February 2, 2015

Federal Specification for the Star-of-Life Ambulance
KKK-A-1822F
Dated 1 August 2007
Change Notice 7

THIS CHANGE NOTICE IS CUMULATIVE, AND INCORPORATES ALL CHANGES INCLUDED IN CHANGE NOTICES 1-6. IT SUPERCEDES NON-CUMULATIVE CHANGE NOTICES 1-6, AND SHALL BE RETAINED UNTIL SUCH TIME AS THE STANDARD IS REVISED.

Add FIGURE 6

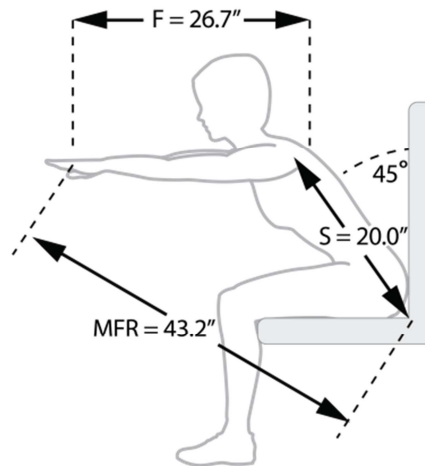
Seats and restraints should be designed to allow all EMSPs to reach patients with at least one hand at a maximum functional reach from a seated and restrained position. This includes a 5th female EMSP with a maximum functional reach of 43.2 inches as measured from the junction of the seat pan and seat back to the thumb tip of the arm fully extended parallel to the floor while leaning at a maximum 45° degree angle. (see figure 6)

Maximum Functional Reach Maximum functional reach is measured from the center point of the junction of the seat pan and seat back to the thumb tip where the arm is fully extended parallel to the floor and the torso is leaning forward at a 45° angle. Maximum functional reach is calculated using the following formula, where F = functional reach and S = seat to shoulder sitting height.

As an example using anthropometric data from MIL-STD-1472G, the maximum functional reach for a 5th percentile female, illustrated below is calculated using the seat (bottom of buttocks) to shoulder torso length (20.0 inches [508 mm]) leaned forward at a 45° degree angle and a functional reach as measured from the shoulder blade to thumbtip (26.7 inches [677 mm]) for a maximum functional reach of 43.2 inches (1097 mm).

$$\text{Maximum functional reach (MFR)} = \sqrt{F^2 + \frac{2FS}{\sqrt{2}} + S^2}$$

$$MFR = \sqrt{26.7^2 + \frac{2(26.7)(20)}{1.41} + 20^2} = 43.2 \text{ inches}$$
